Re: An Application for a CPCN for the 2009-2010 Capital Expenditure Plan Project No. 3698519

Please find enclosed FortisBC Inc.'s responses to Information Request No.1 from the BC Utilities Commission. Twenty copies will be couriered to the Commission.

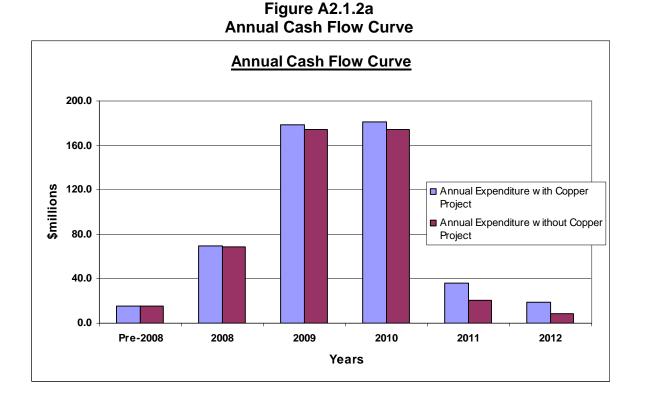
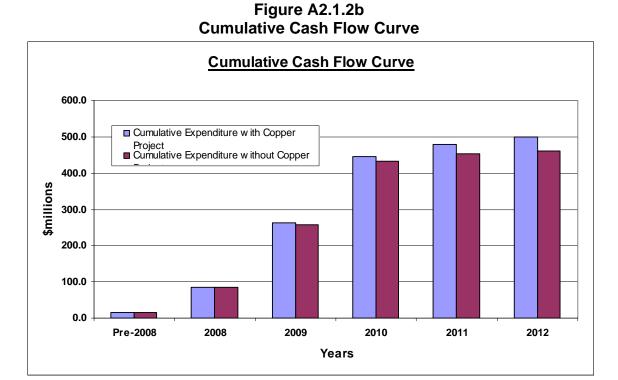
1Q2.1.2Please provide the annual cash flow curves and cumulative cash2flow curves for these tables.

A2.1.2 Please see Figures A2.1.2a and A2.1.2b below.

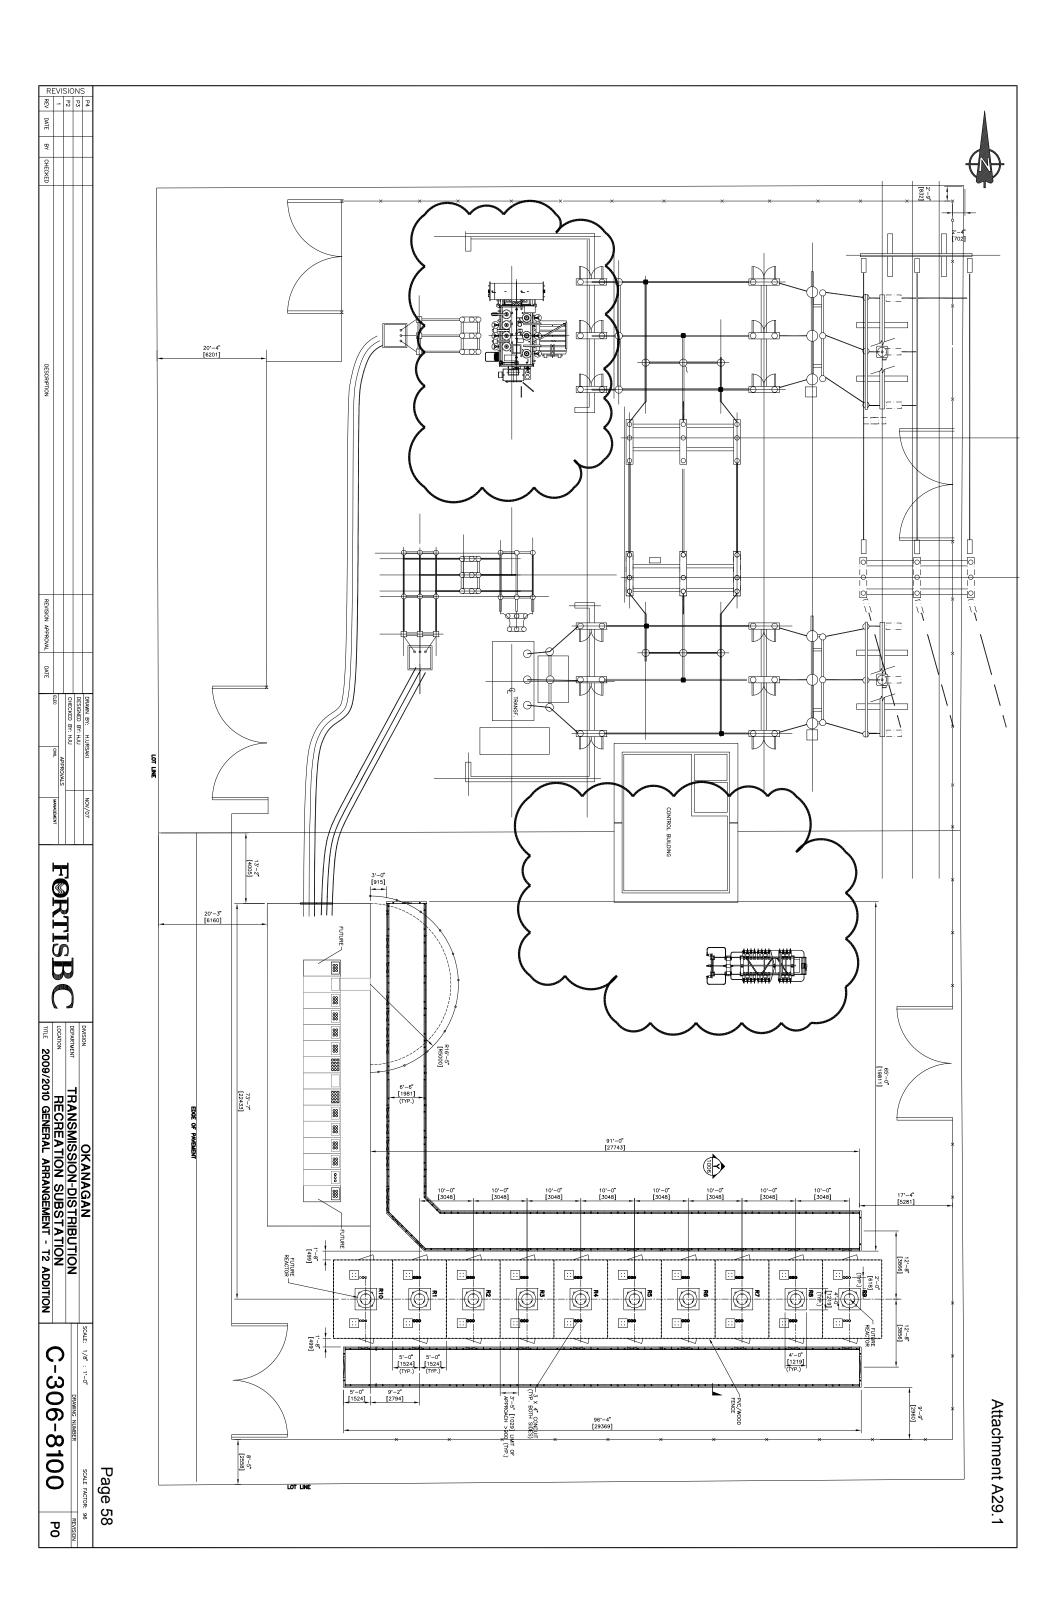
1	29.0	Reference: 3. Transmission and Stations, Transmission and Station
2		Growth Projects
3		Exhibit No. B-1, Recreation Substation, p. 49
4		Siting
5	Q29.1	Would FortisBC please supply conceptual substation and transmission
6		line siting diagrams including footprints and existing as well as new
7		statutory rights-of-way?

8 A29.1 Please see Attachment A29.1.

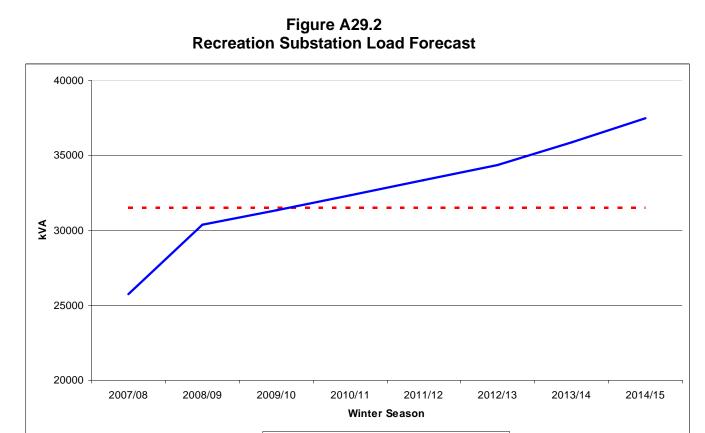
1 Q29.2 Would FortisBC please supply the load demand curve justifying the need

for this substation?

- 3 A29.2 Please see Figure A29.2 below.
- 4 5

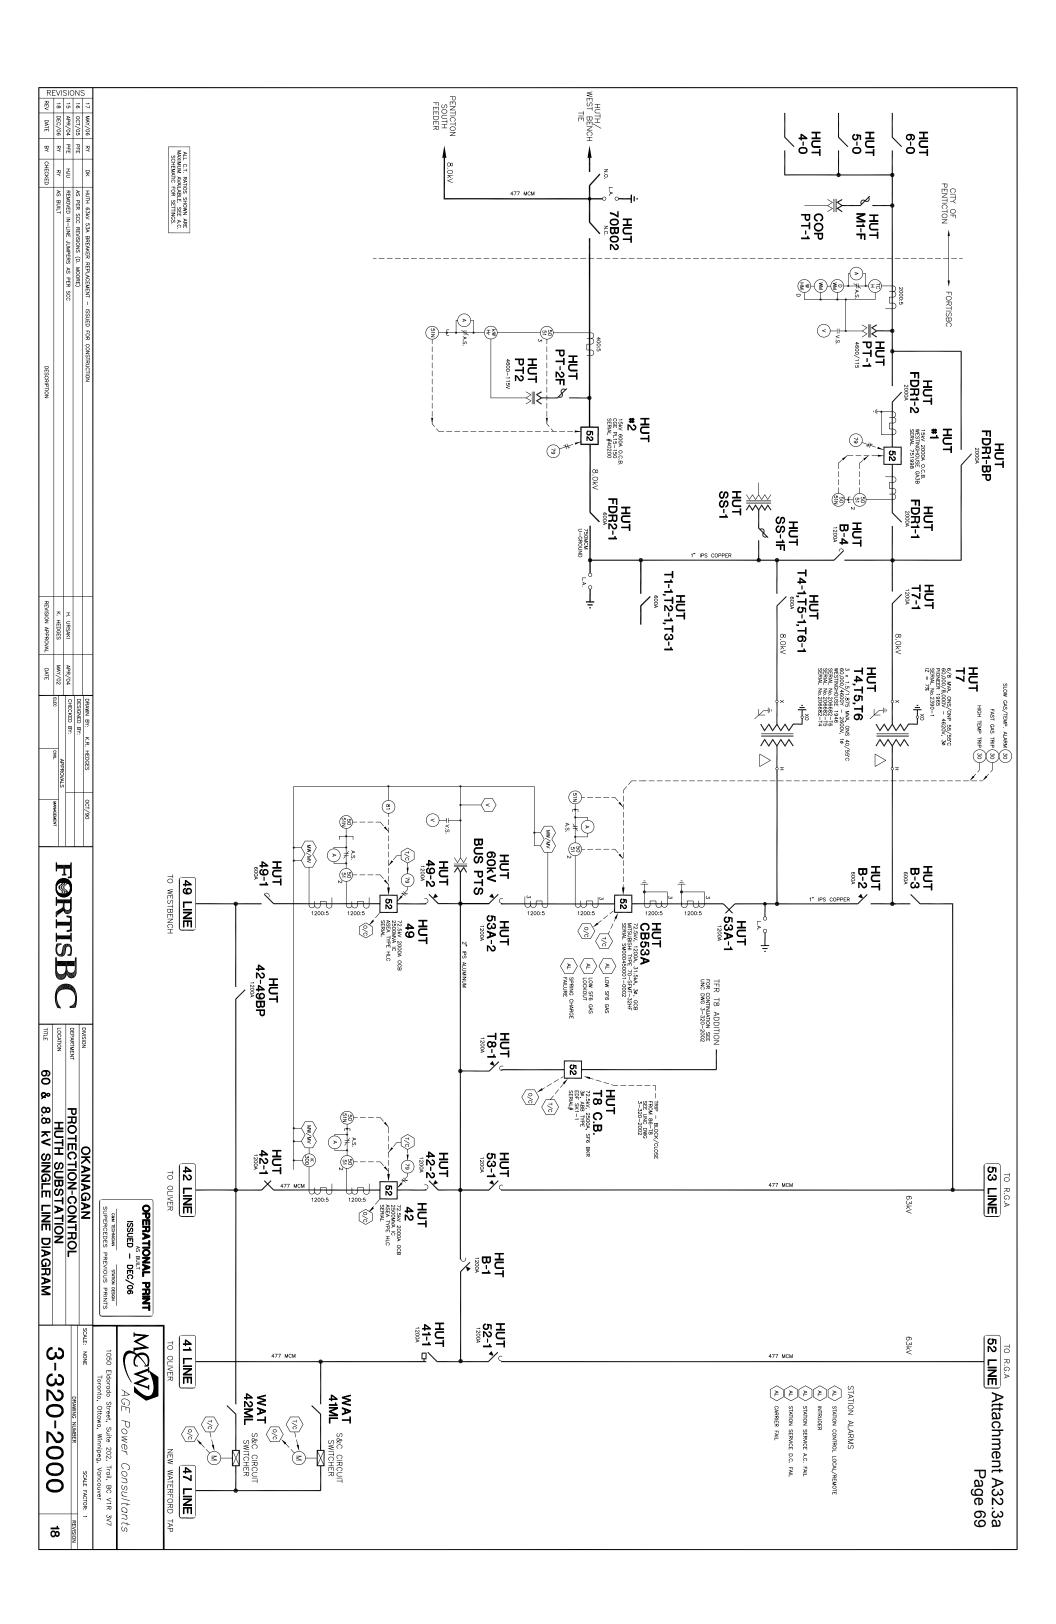
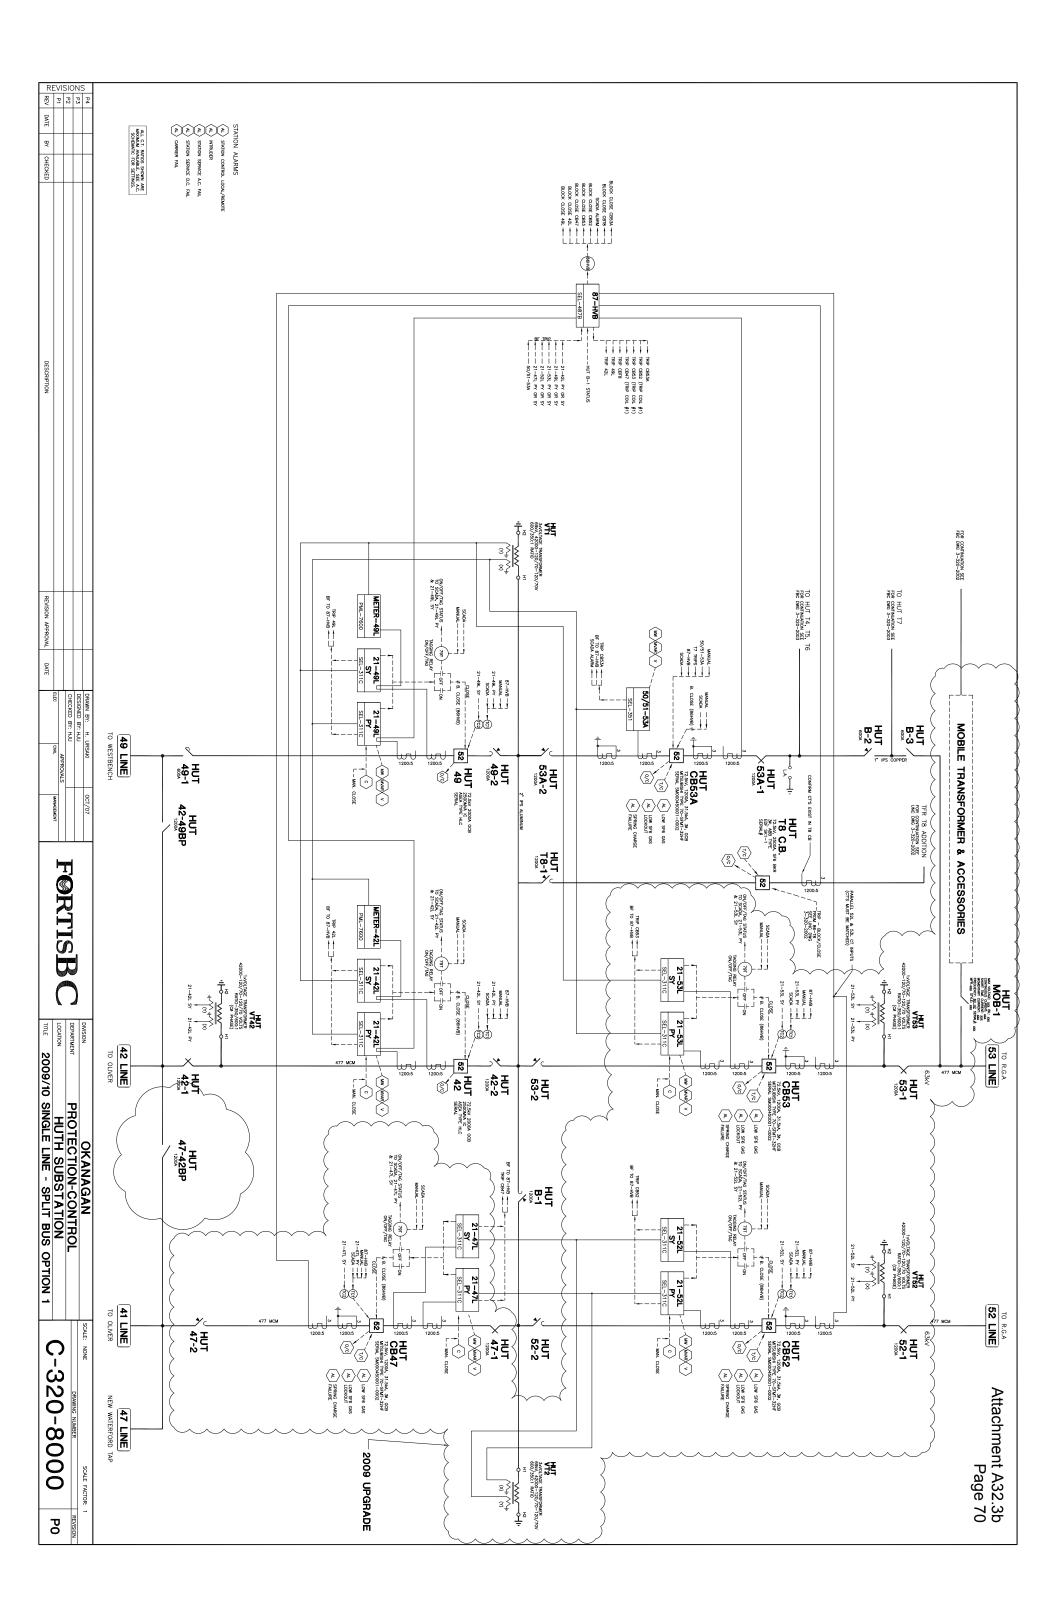
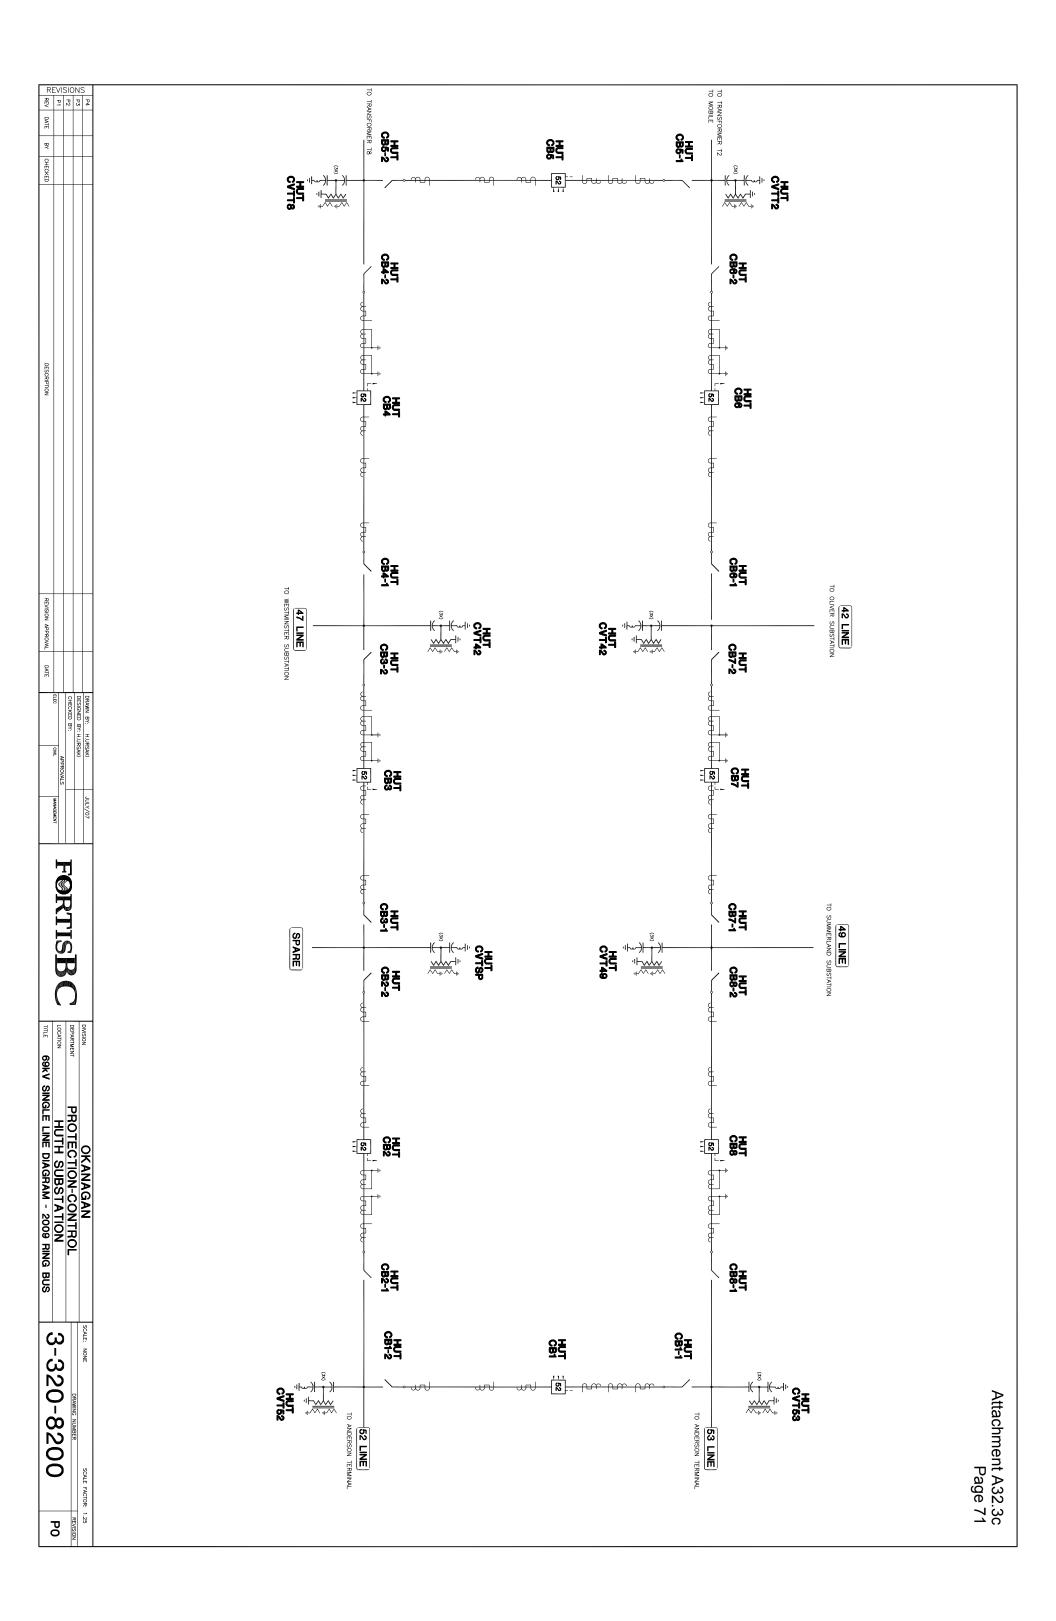
1 2	Q32.2	Would FortisBC please identify if there have been any reported safety issues with this substation since 1950?
3 4	A32.2	Although the station is a legacy substation and does not necessarily meet current construction standards, no specific safety issues have been identified.
5 6	Q32.3	Would FortisBC please provide single line diagrams for the existing, single-us configuration and the ring bus alternative?
7 8	A32.3	Please see Attachment A32.3a below depicting the existing configuration, Attachment A32.3b depicting a split bus configuration, and Attachment A32.3c

9 depicting a ring bus configuration.

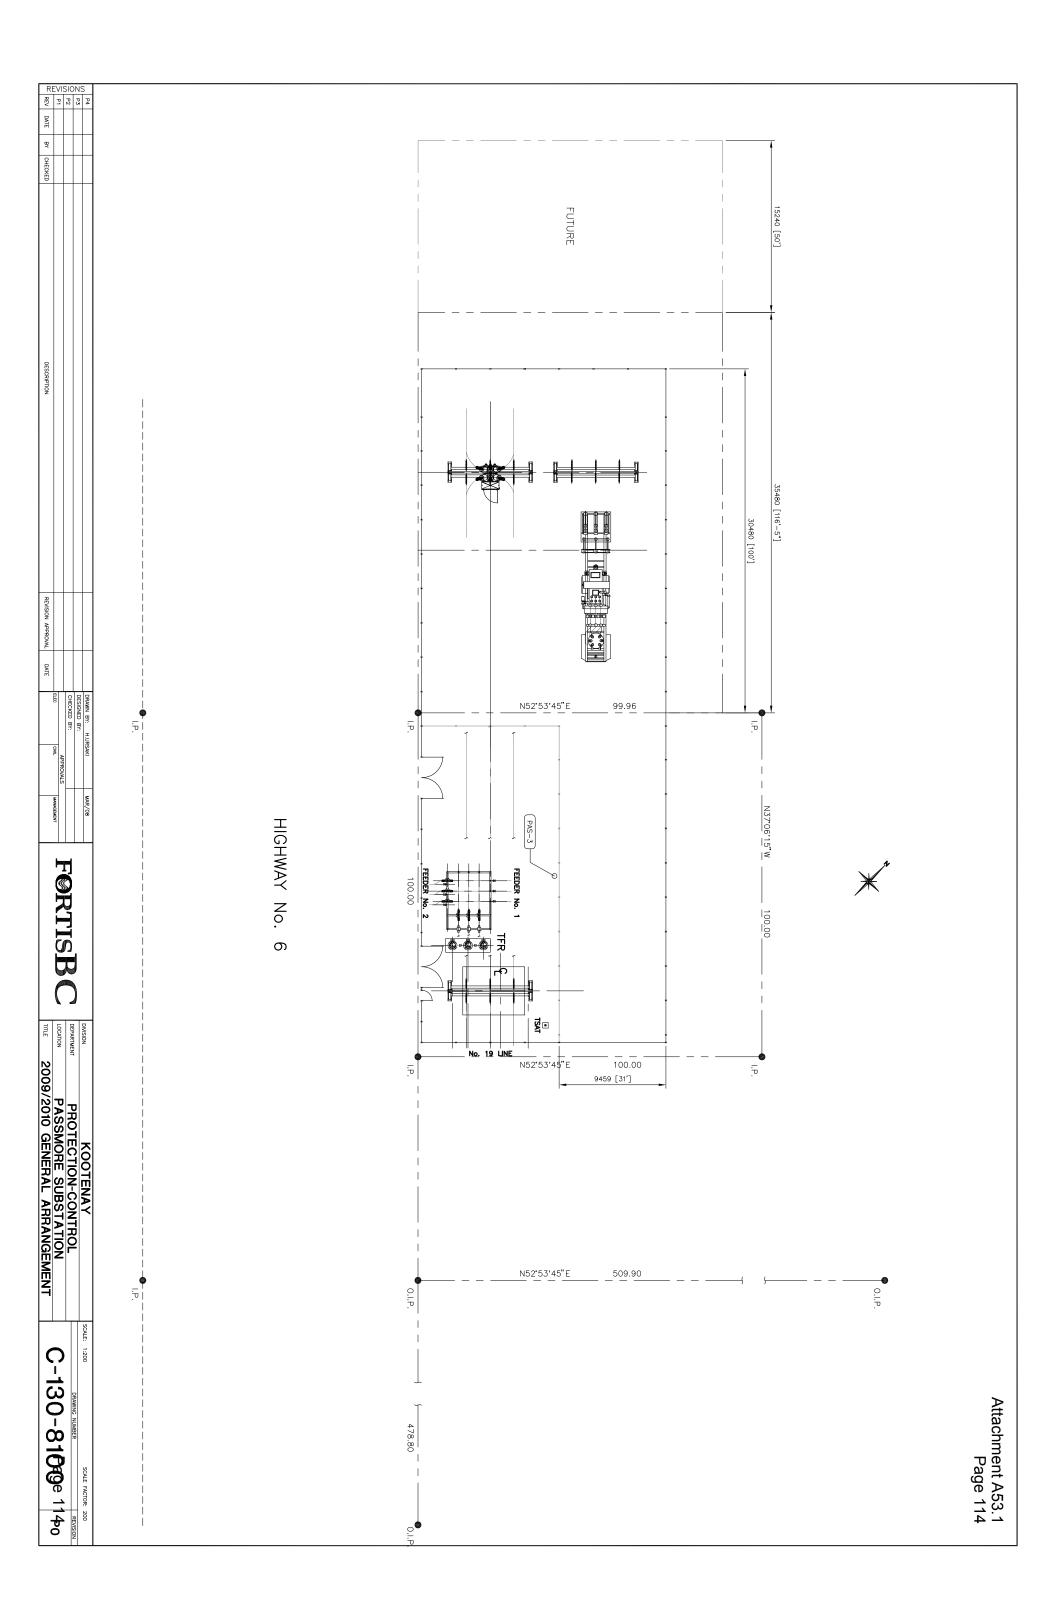
1	53.0	Reference: 3. Transmission and Stations, Station Sustaining Programs
2		and Projects
3		Exhibit No. B-1, Passmore Substation Upgrade, p. 71
4		Substation Expansion
5	Q53.1	Would FortisBC please supply conceptual substation and transmission
6		line siting diagrams including footprints and existing as well as new
7		statutory rights-of-way that may be required?

8 A53.1 Please see attachment A53.1 below.

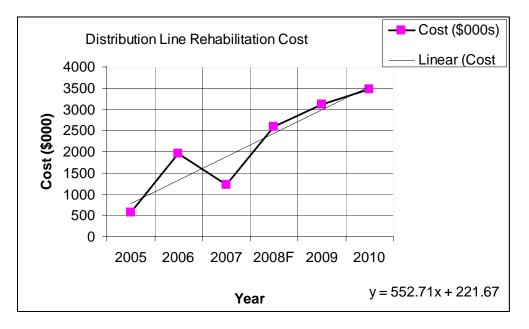
10Q67.4As these estimates are based on historical information, please explain the11additional annual growth in the annual estimated funds required of12\$500,000/year. See Chart.

A67.4 As noted in the 2009-2010 Capital Plan (Exhibit B-1), page 89, line 28 and 29,
 the historical average has been increased by \$750,000 per year for 2009 and
 2010 to accommodate Hot Tap Connector replacements.
